APPLICATION NO.	FILING DATE	FIRST NAMED INVENTOR	ATTORNEY DOCKET NO.	CONFIRMATION NO.
10/578,001	05/03/2006	Shunpei Yamazaki	740756-2967	3719
22204 NIXON PEABO	7590 11/13/200 ODY, LLP	EXAMINER		
401 9TH STRE		KARIMY, MOHAMMAD TIMOR		
SUITE 900 WASHINGTON, DC 20004-2128			ART UNIT	PAPER NUMBER
			2894	
			MAIL DATE	DELIVERY MODE
			11/13/2008	PAPER

Application No.	Applicant(s)				
Office Action Summary		10/578,001	YAMAZAKI ET AL.				
		Examiner	Art Unit				
		MOHAMMAD Timor KARIMY	2894				
Period fo	The MAILING DATE of this communication a or Reply	ppears on the cover sheet with the	correspondence address				
A SHORTENED STATUTORY PERIOD FOR REPLY IS SET TO EXPIRE 3 MONTH(S) OR THIRTY (30) DAYS, WHICHEVER IS LONGER, FROM THE MAILING DATE OF THIS COMMUNICATION. - Extensions of time may be available under the provisions of 37 CFR 1.136(a). In no event, however, may a reply be timely filed after SIX (6) MONTHS from the mailing date of this communication. - If NO period for reply is specified above, the maximum statutory period will apply and will expire SIX (6) MONTHS from the mailing date of this communication. - Failure to reply within the set or extended period for reply will, by s

FIG.5

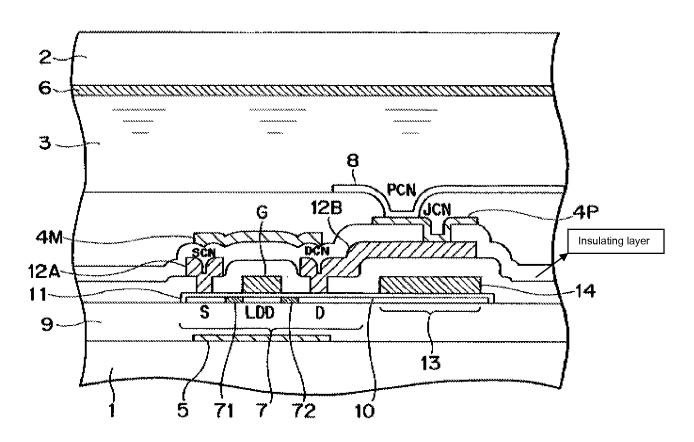
With respect to claim 1, Hashimoto discloses in figures 1-7, a thin film transistor comprising:

an insulating layer (see Fig. 5 below) having a first opening;

a first conductive layer 12B in the first opening;

a second conductive layer 4p on and in contact with the first insulating layer and the first conductive layer 12B;

wherein the first conductive layer 12B is **wider and thicker** than the second conductive layer 4p.

With respect to claim 10, Hashimoto implicitly teaches in Fig. 5 the thin film transistor of claim 1, wherein the thin film transistor further comprises a light

shielding film 5 below the first conductive layer 12B (Hashimoto teaches titanium as the material for a similar light shield film in Para [0005]).

With respect to claim 19, Hashimoto implicitly teaches in Fig. 5 the thin film transistor of claim 1, wherein a television apparatus can include the thin film transistor of claim 2.

With respect to claim 2, Hashimoto discloses in figures 1-7, a thin film transistor comprising:

an insulating layer (see Fig. 5 above) having a first opening;

a first conductive layer 12B in the first opening;

a second conductive layer 4p on and in contact with the first insulating layer and the first conductive layer 12B;

wherein the first conductive layer 12B is **wider and thicker** than the second conductive layer 4p.

The limitation "wherein the second conductive layer is formed by a droplet discharge method using a conductive material" is a product by process limitation, and it does not result to a structurally distinguishable product over Hashimoto's device. Moreover, the method of forming a device is not germane to the issue of
